RE: Cosme Retail (Central Ave)

Grading and Drainage Plan

Engineer's Stamp Date 3-15-2017 (File: K11D077)

Based upon the information provided in your submittal received 3-17-2017, the above referenced Grading and Drainage Plan is approved for building permit based on following conditions:

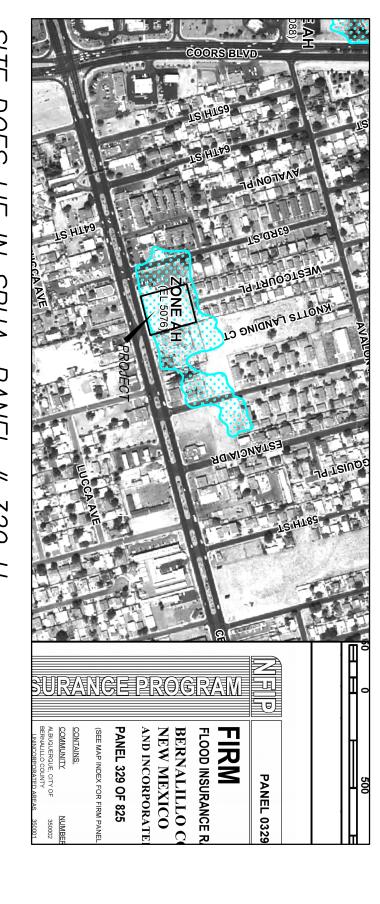
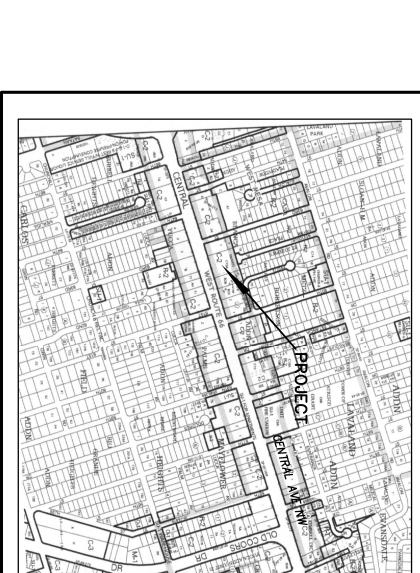
- A foundation survey is required.
- Floodplain permit application required.
